AMENDMENT TO THE

PIKE RIVER WATERSHED PLAN

**CITY OF KENOSHA/
TOWN OF SOMERS**

REPORT ON IMPACTS OF STH 32 IMPROVEMENT AND CARTHAGE COLLEGE DIKE ON THE PLANNED 100-YEAR RECURRENCE INTERVAL FLOOD PROFILE FOR THE LOWER PIKE RIVER

Exhibit C

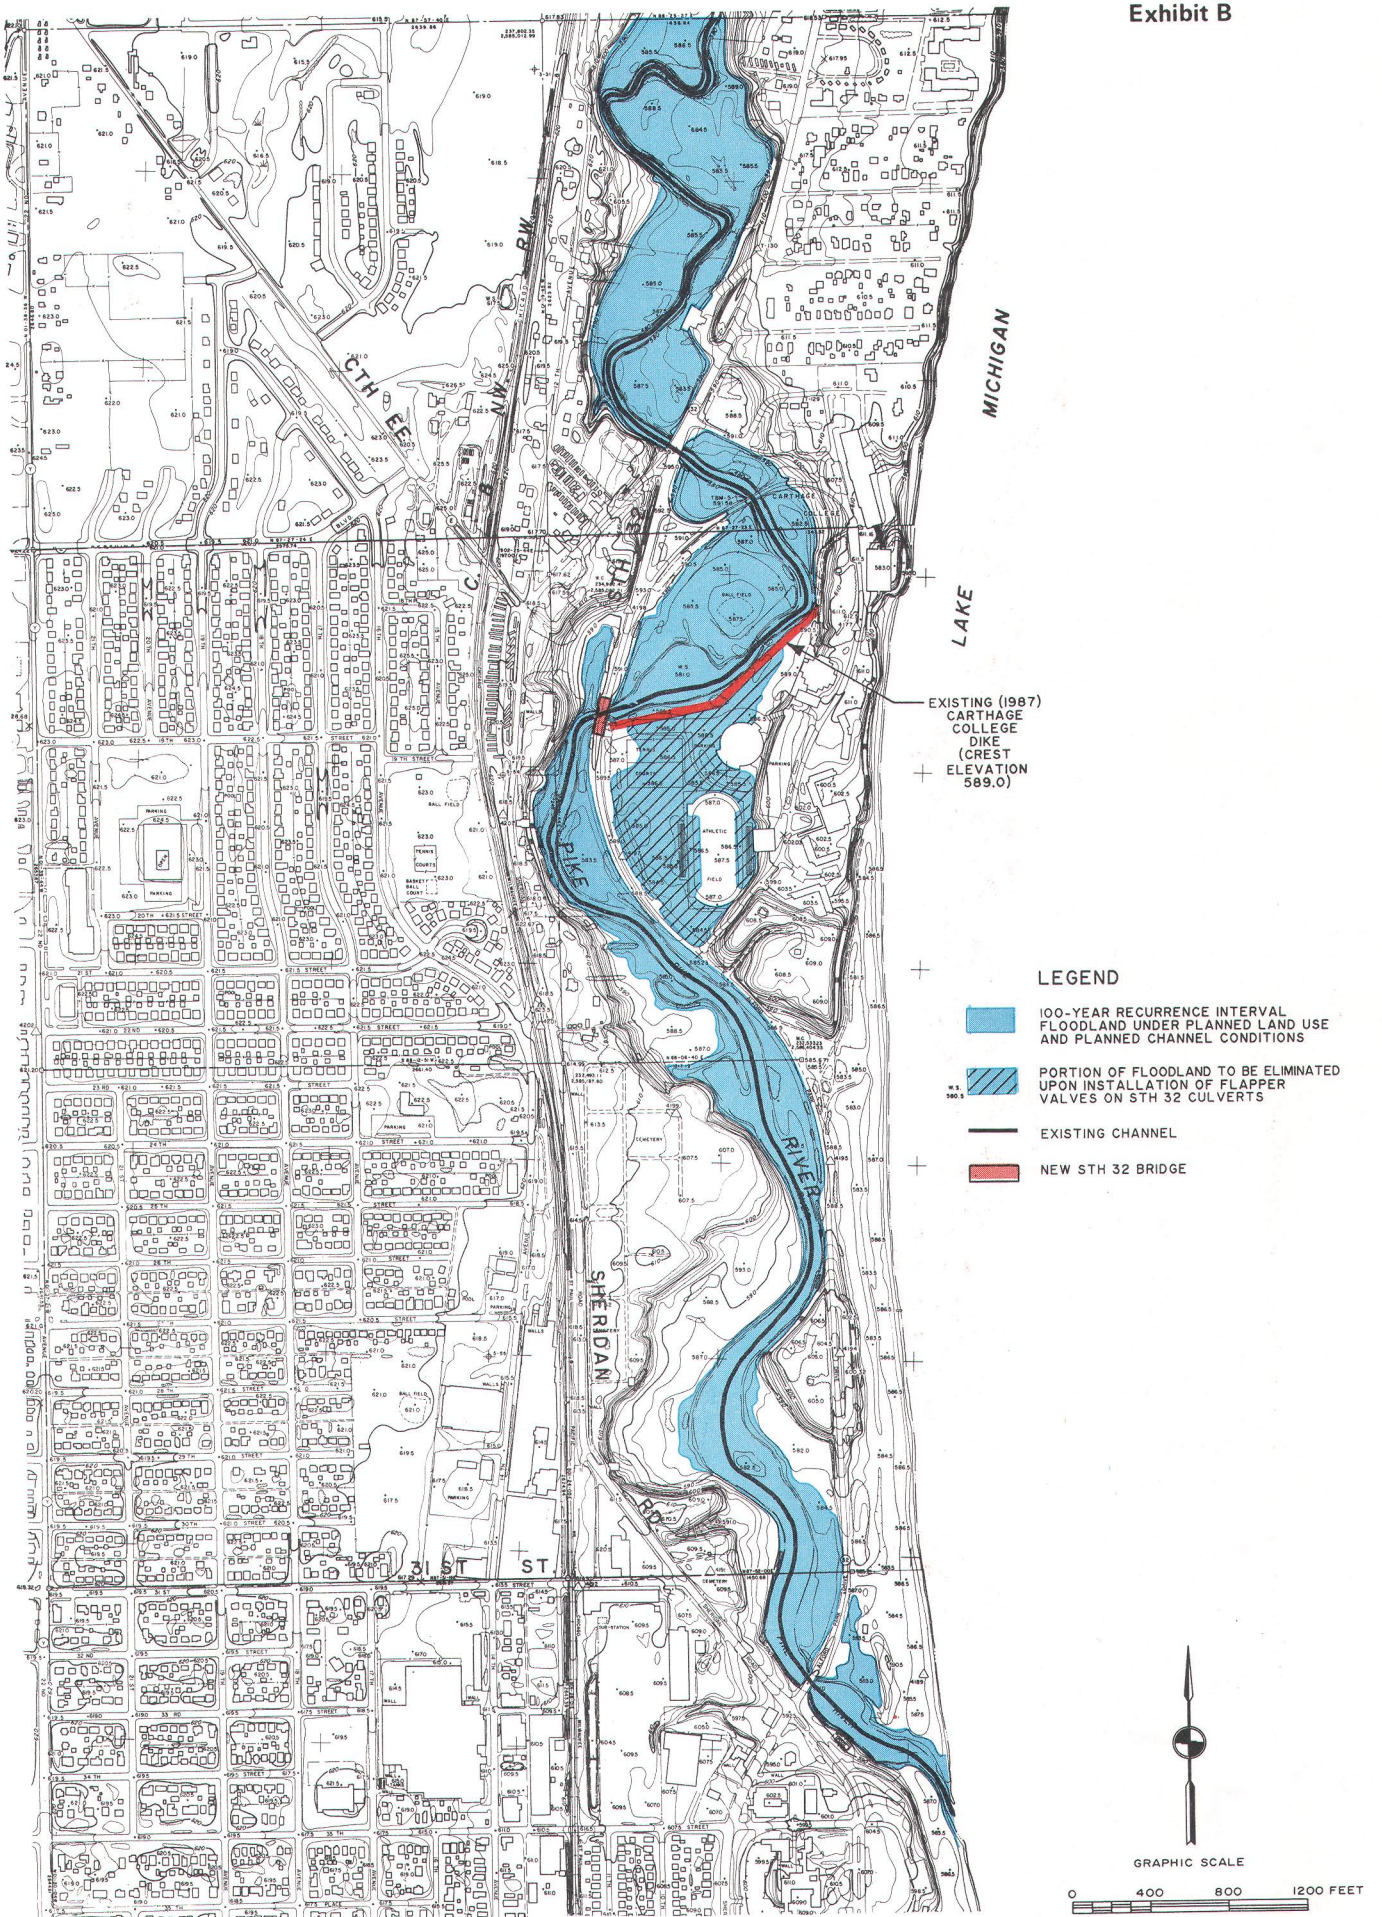
3. The planned 100-year recurrence interval floodplain attendant to the recommended plan for the Lower Pike River subwatershed as originally shown on Maps 86 and G-1 on pages 516 and 638 respectively, of SEWRPC Planning Report No. 35 is hereby revised to reflect the Carthage College dike and the new STH 32 bridge. Copies of the revised Maps 86 and G-1 are attached hereto as Exhibits E and C.

NOTE: THIS EXHIBIT REPLACES MAP G-1 ON PAGE 638 IN SEWRPC PLANNING REPORT NO. 35.

FLOOD STAGE AND STREAMBED PROFILE FOR THE PIKE RIVER (RIVER MILE 0.00 TO 4.50)

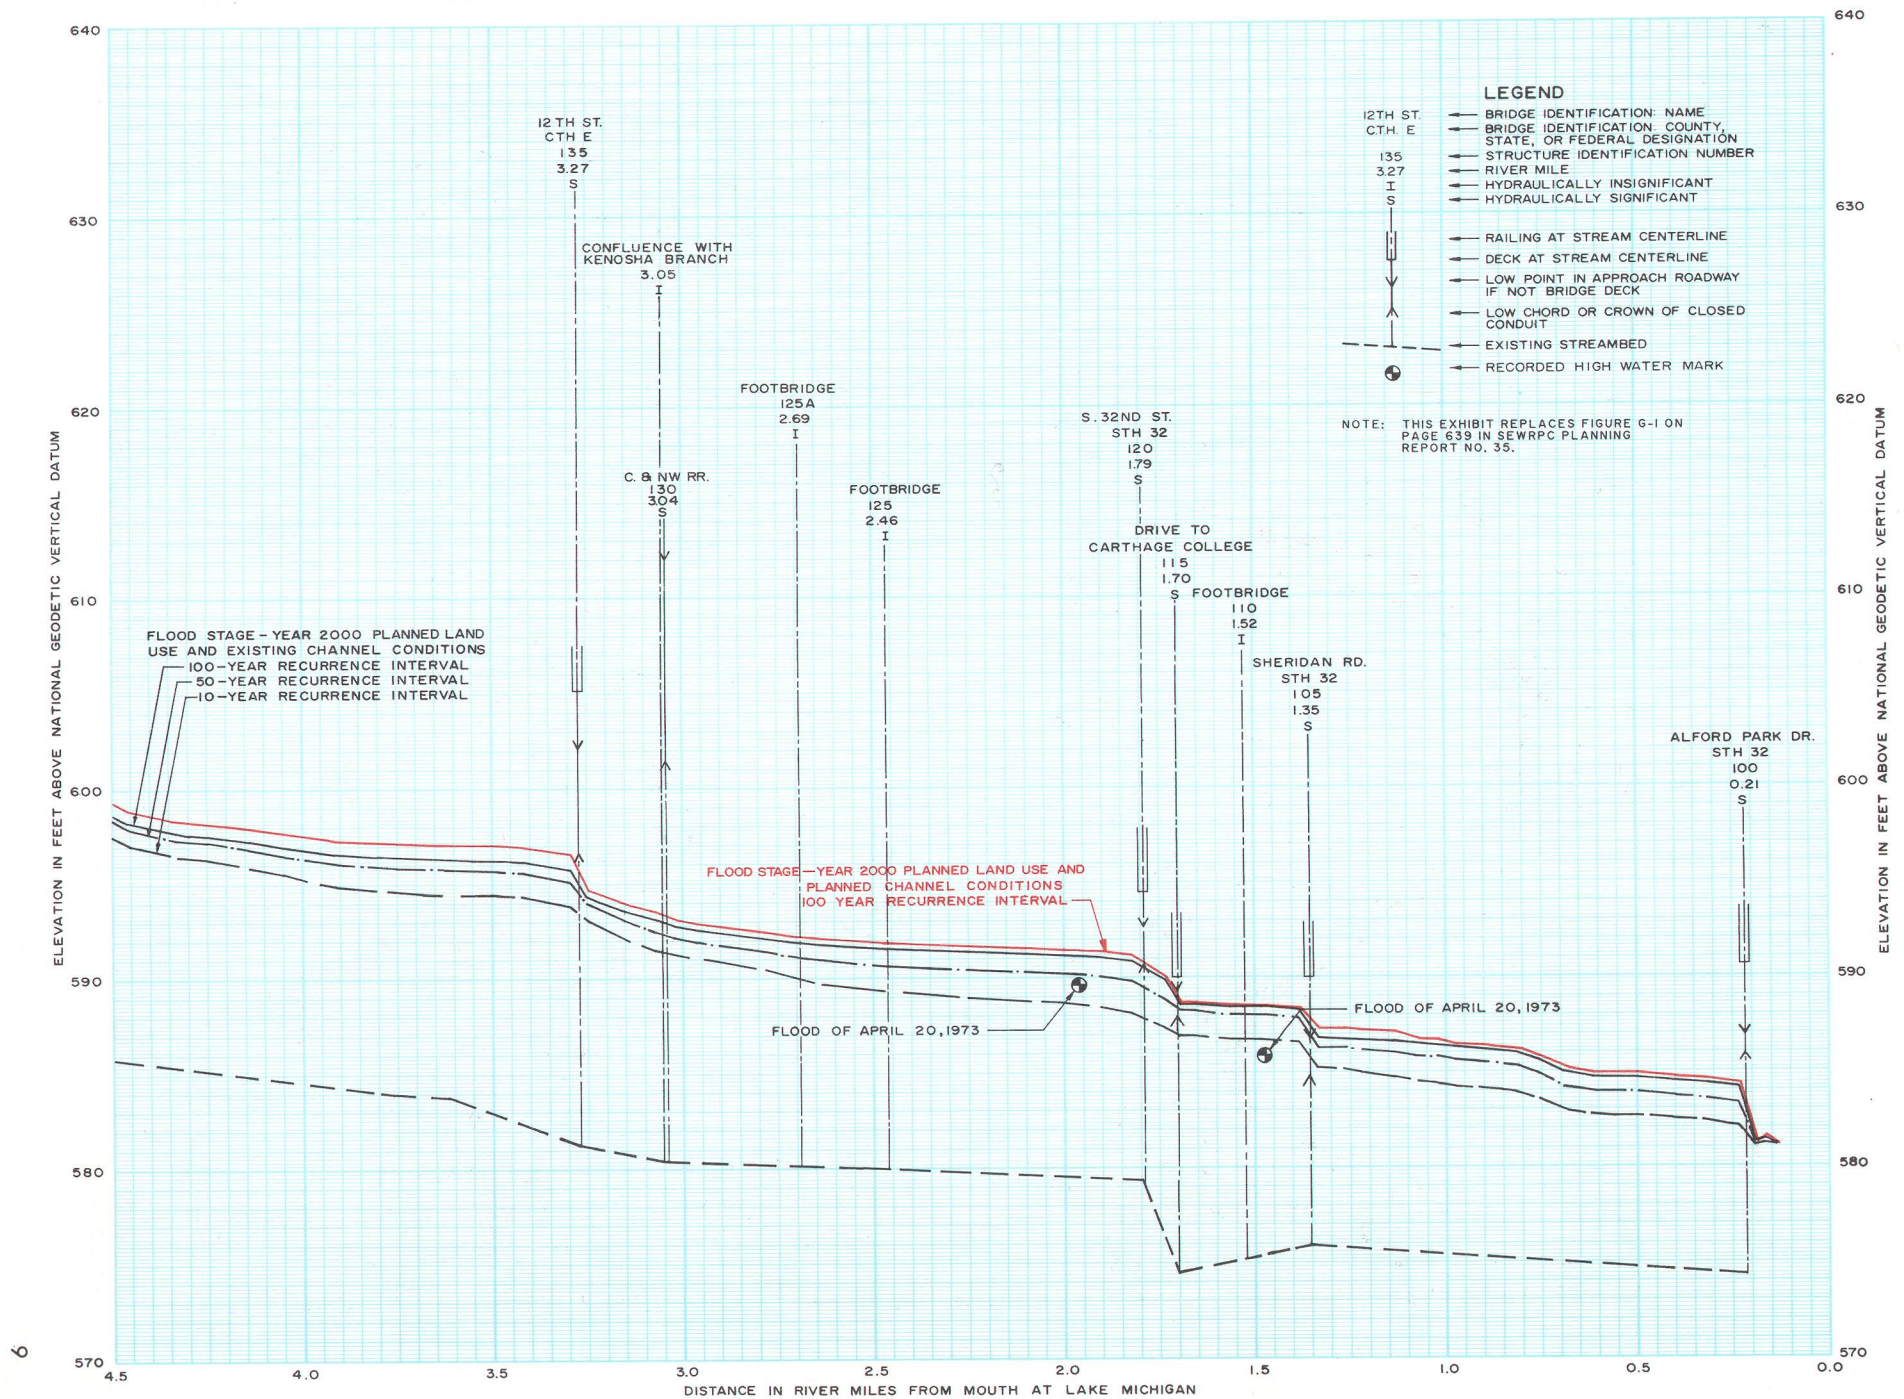
2. The flood stage and streambed profiles for the Pike River as set forth in Figure G-1 on page 639 of SEWRPC Planning Report No. 35 are hereby revised to reflect the Carthage College dike and the new STH 32 bridge. A copy of the revised Figure G-1 is attached hereto as Exhibit D.

LOCATION OF STRUCTURES ALONG THE LOWER PIKE RIVER WHERE FLOODPROOFING MEASURES ARE RECOMMENDED

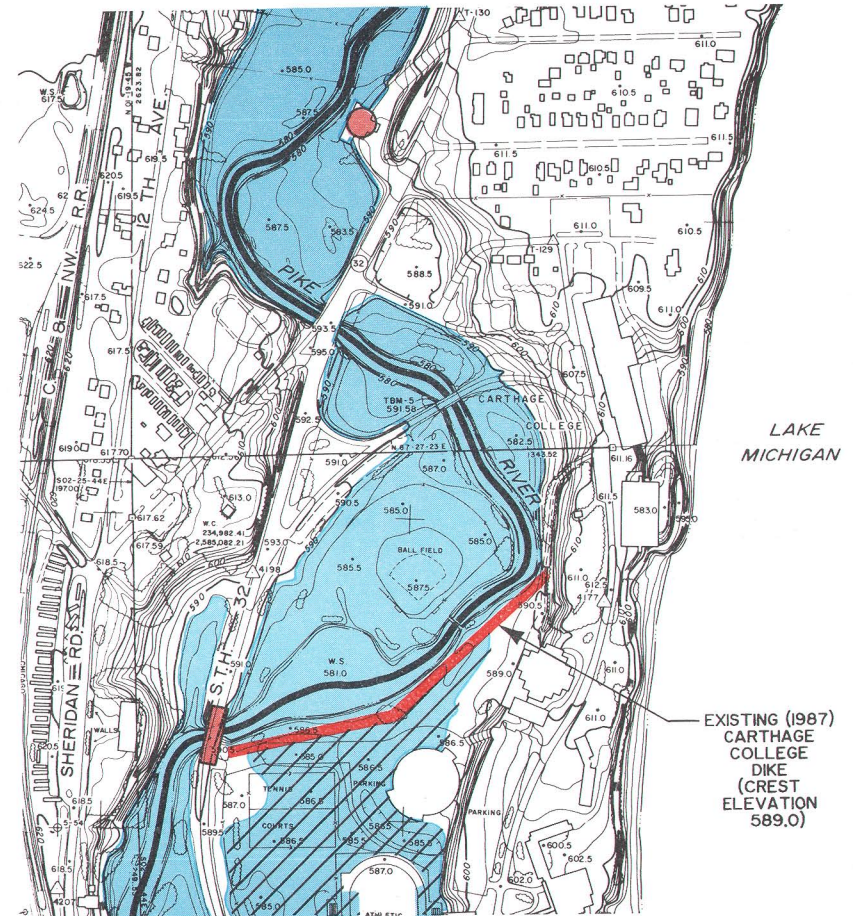
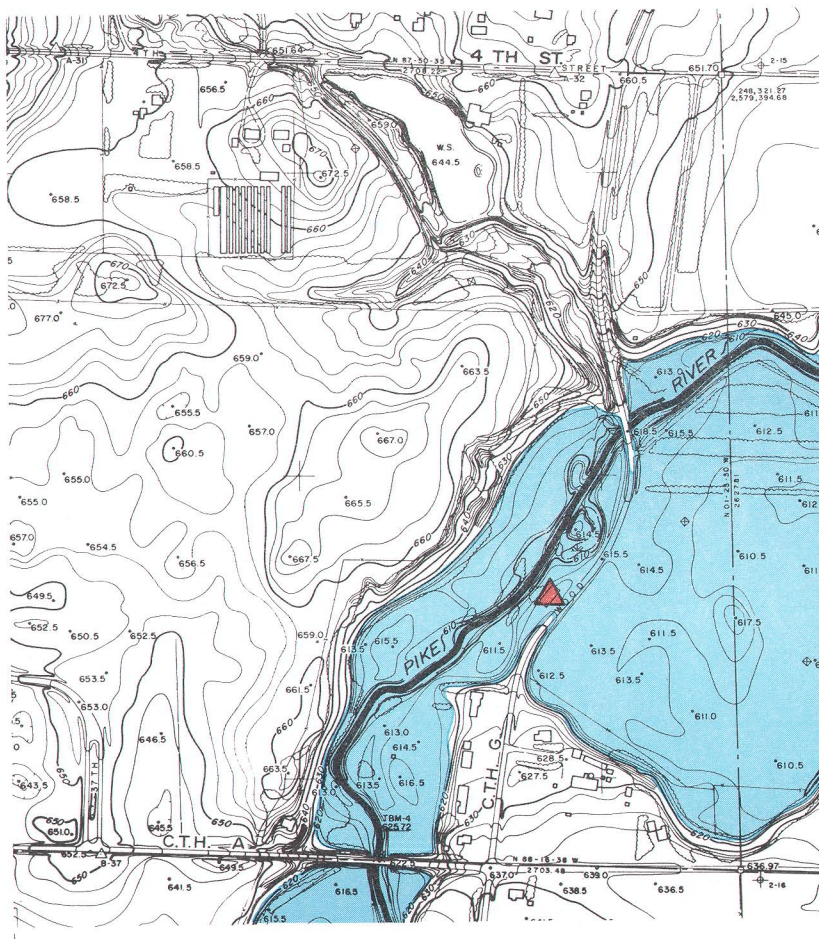
Most of the STH 32 reconstruction project was completed in late 1986. The revised floodplain attendant to the changes as described in the implemented alternative is shown on the map attached hereto as Exhibit B. While the alternative implemented by the Wisconsin Department of Transportation allows for the retention of the Carthage College flood control dike at its current crest elevation without any increase in the upstream stage of the regulatory flood, above the upstream stage elevation that existed prior to the 3.0-foot raising of the dike, and while the dike protects the College grounds from overland floods during major flood events, the College grounds are still subject to flood inundation due to the Pike River backwater discharging through culverts under STH 32. The flood inundation from this source should be eliminated upon completion of the STH 32 reconstruction project in the summer of 1987, as flapper valves to prevent the backwater discharge onto the College grounds are installed on the culverts as part of the project plans.

NOTE: THIS EXHIBIT REPLACES MAP 86 ON PAGE 516 IN SEWRPC PLANNING REPORT NO. 35.
